Subject: AP1000 Response to Request for Additional Information (SRP 3)

RAI-SRP3.7.1-SEB1-11 R2

# AP1000 TECHNICAL REPORT REVIEW

RAI Response Number: RAI-SRP3.7.1-SEB1-11

#### Index for Figures RAI-SRP3.7.1-SEB1-11-11 through RAI-SRP3.7.1-SEB1-11-25:

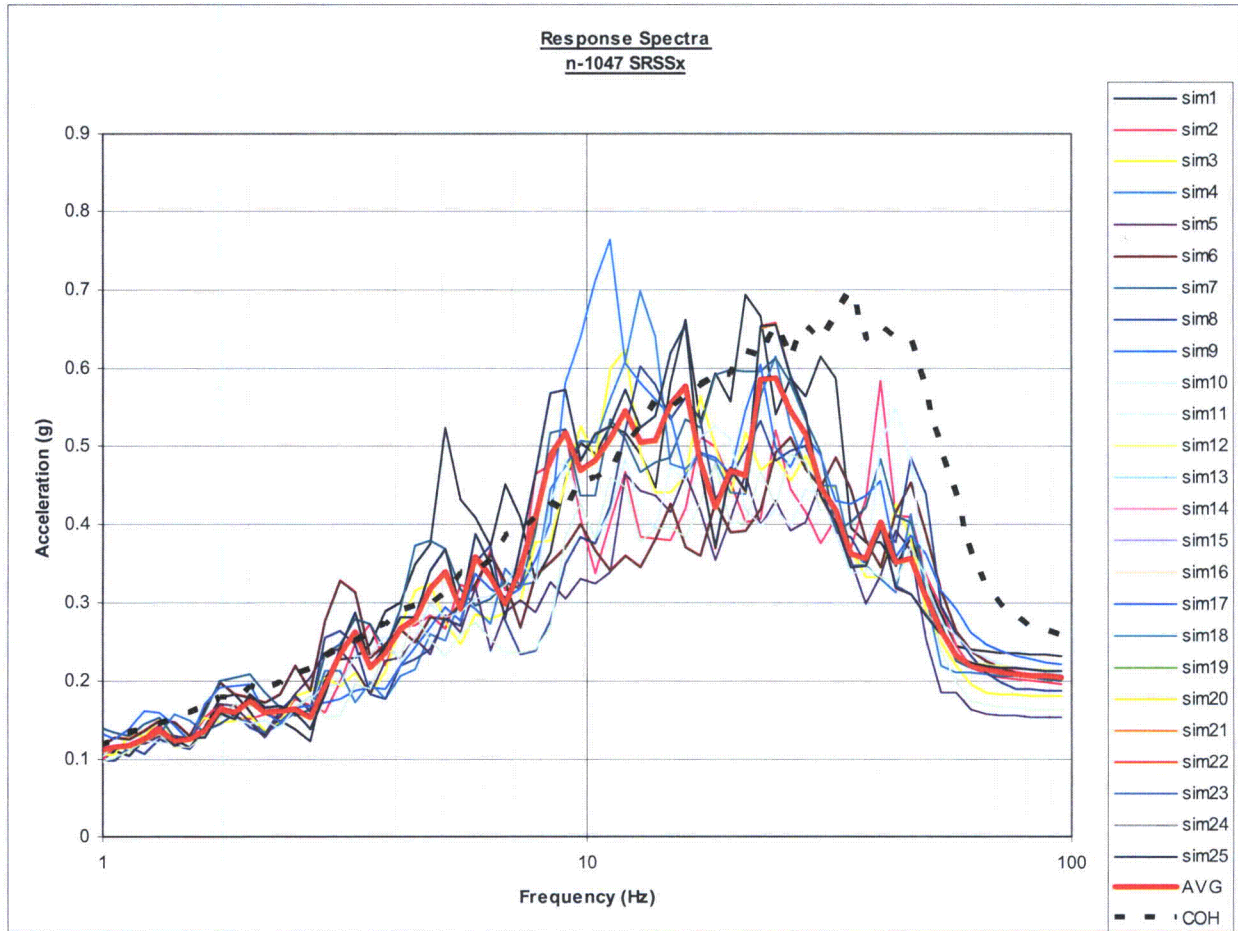
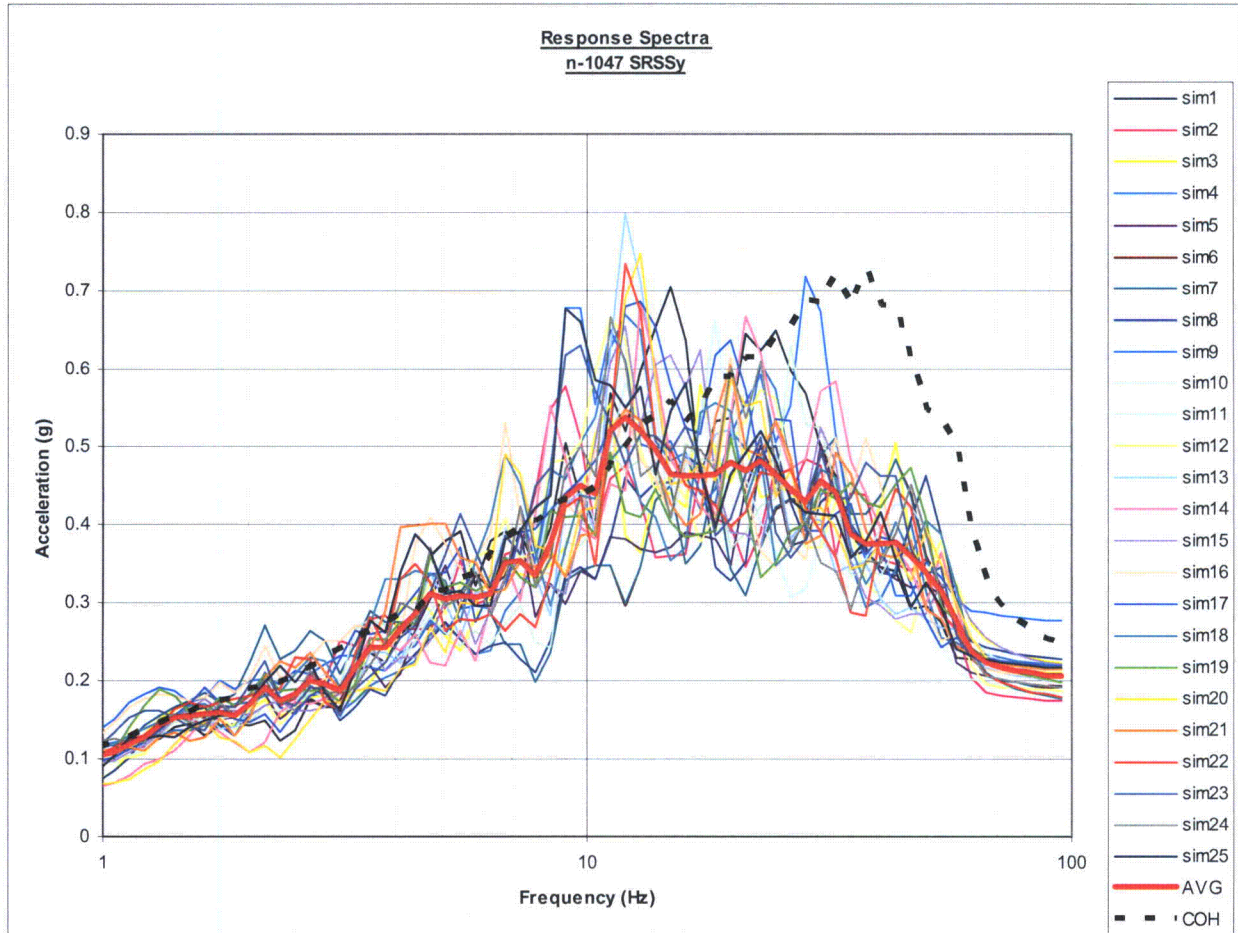
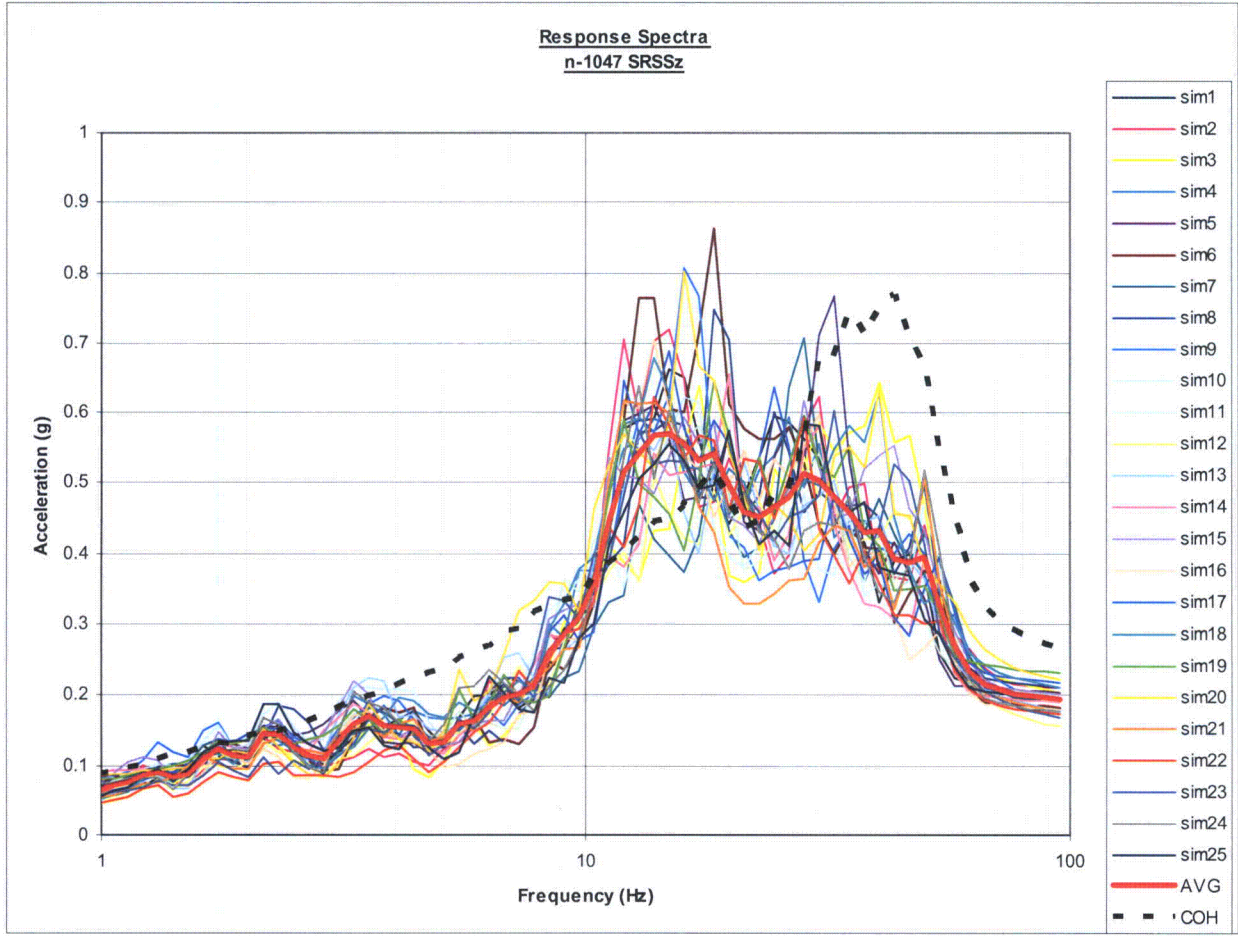
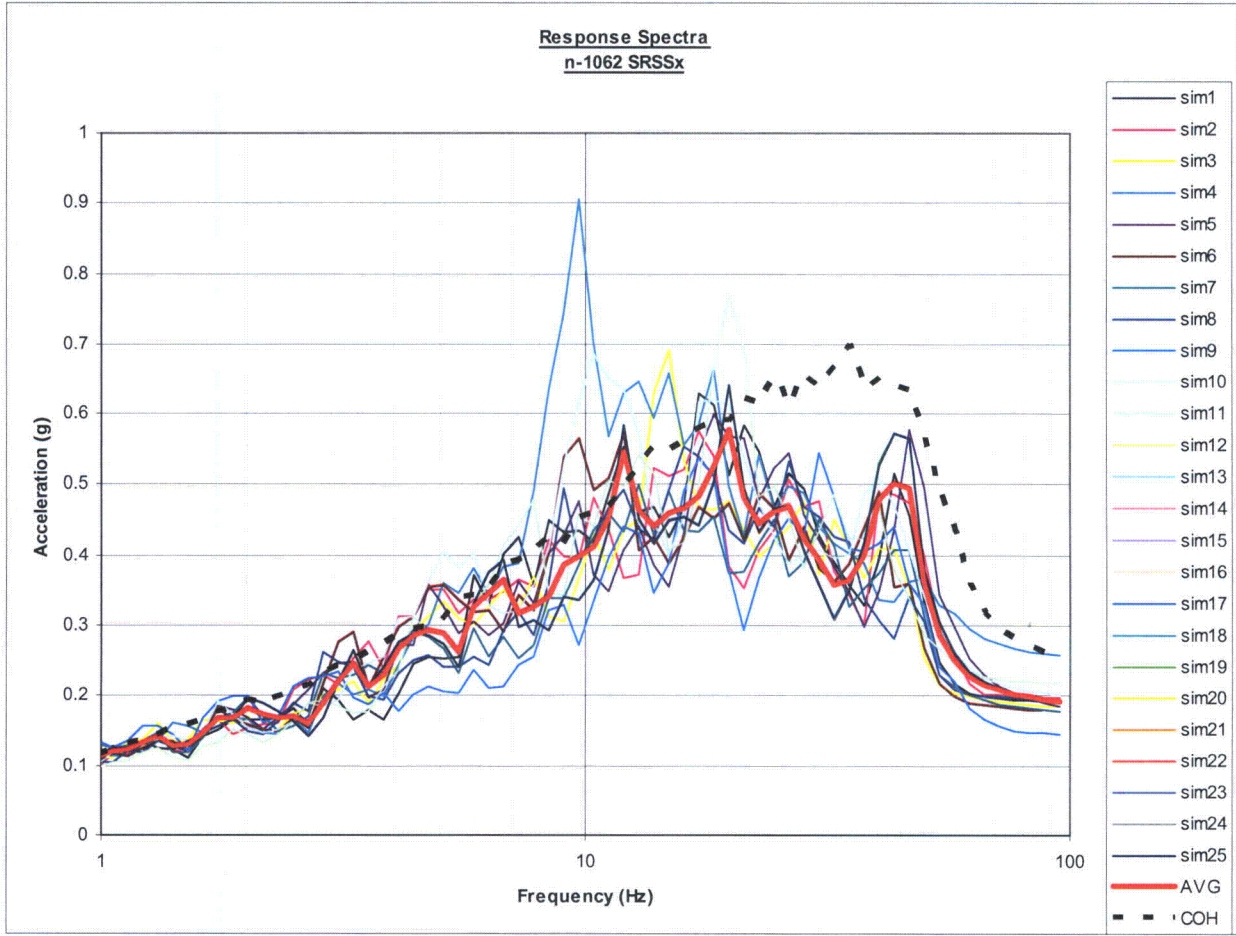
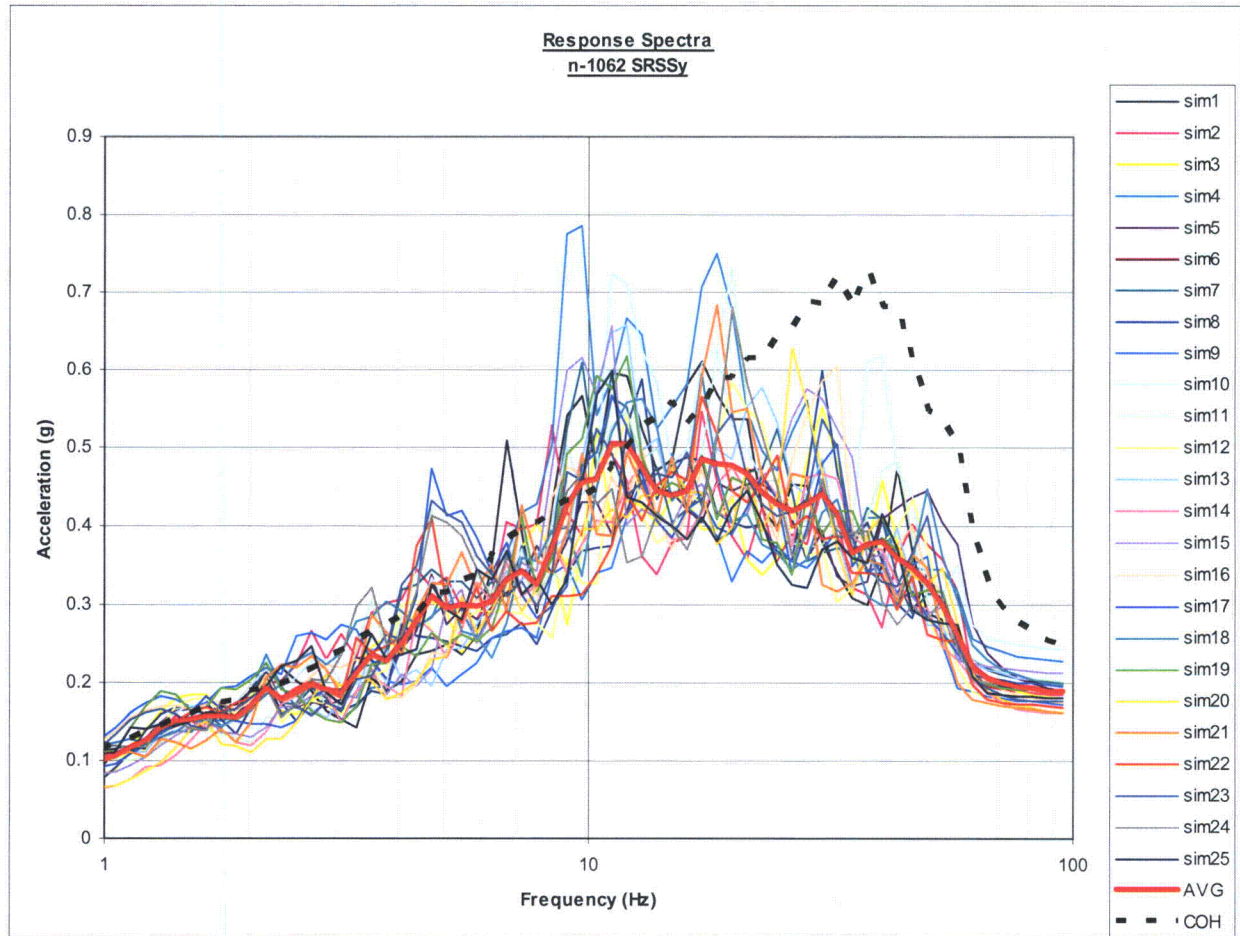
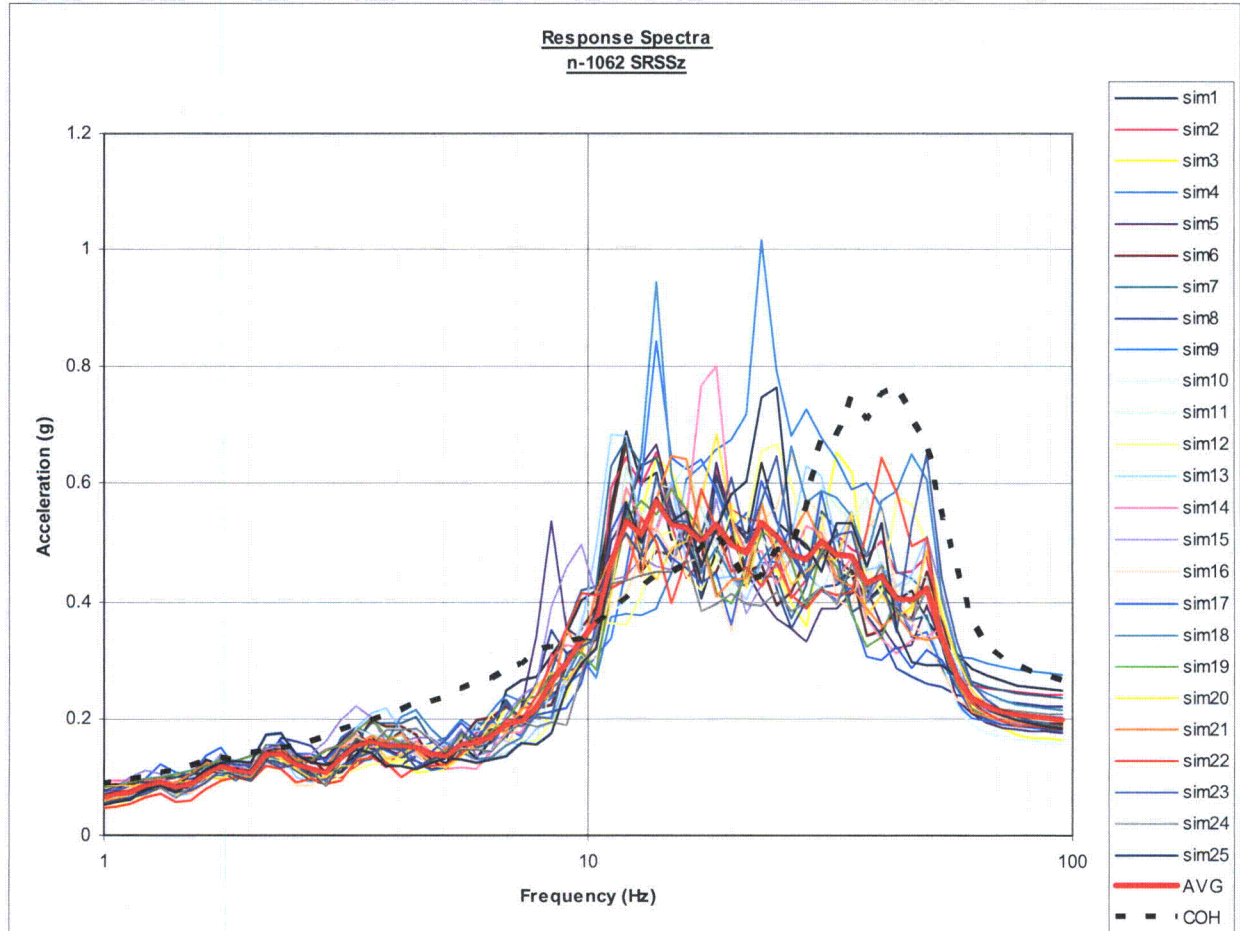
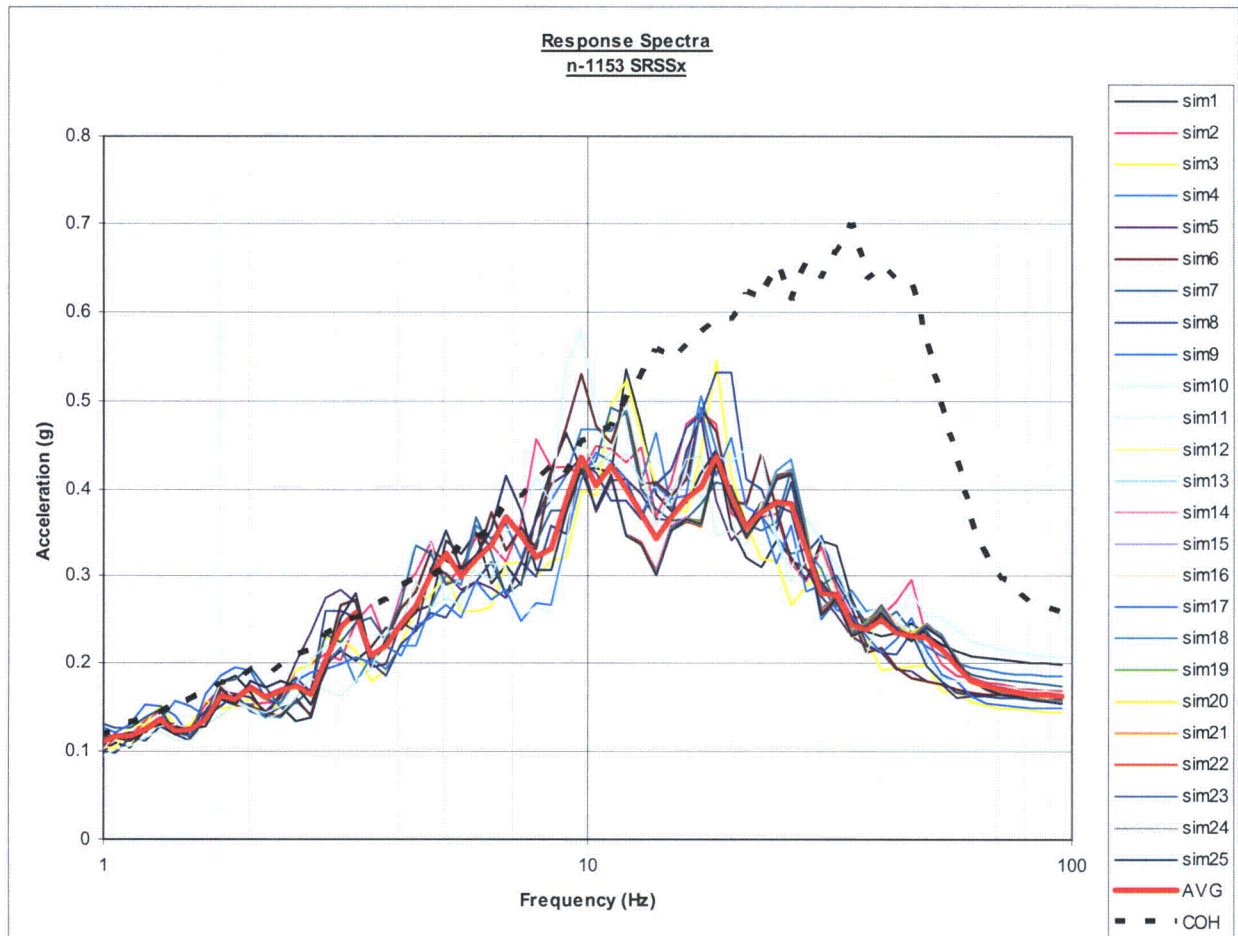
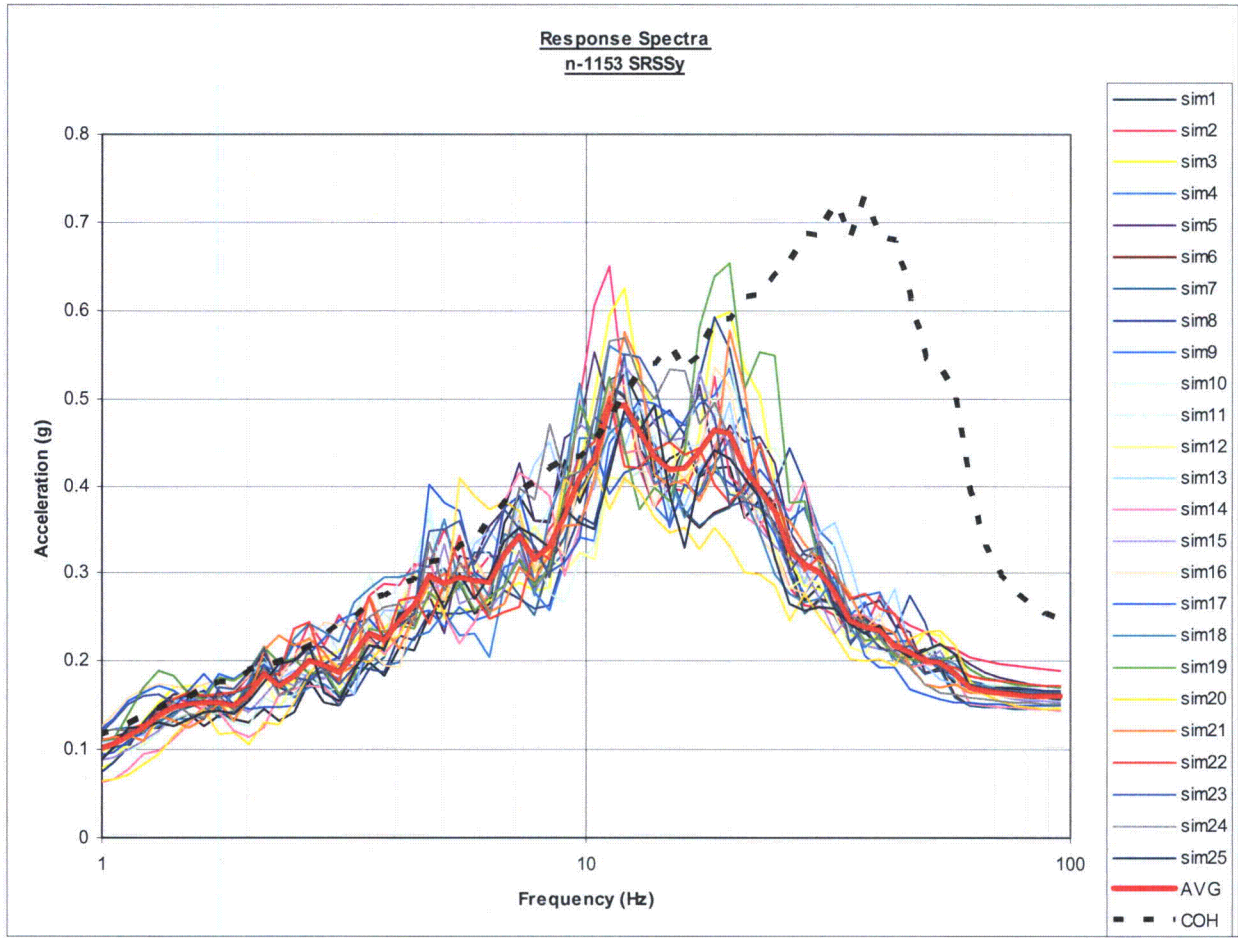
More data, i.e., HRHF response spectra for 5 locations on the basemat (4 locations at 4 corner and center) comparison of coherent at 5 nodes, 25 samples of incoherent and average of 25 incoherent response spectra.

Following the NRC Audit of AP1000 Seismic Design the week of April 13-17, 2009, the NRC has requested additional HRHF FRS at the four corners and center of the Nuclear Island basemat. The nodal locations of the response spectra comparisons have been provided in a plot shown in Figure RAI-SRP3.7.1-SEB1-11-10. A comparison of the SRSS combined X, Y and Z directions for incoherent simulations, average incoherent and coherent FRS are shown in Figures RAI-SRP3.7.1-SEB1-11-11 through RAI-SRP3.7.1-SEB1-11-25. The plots provided show a general reduction in the 25 incoherent simulations when compared to the coherent response in the higher frequencies. At lower elevations, the incoherent simulations exceed the coherent responses in the z-direction around the 10-20 Hz range; these exceedances do not exist at higher elevations as seen in Figures RAI-SRP3.7.1-SEB1-11-1 through RAI-SRP3.7.1-SEB1-11-9.
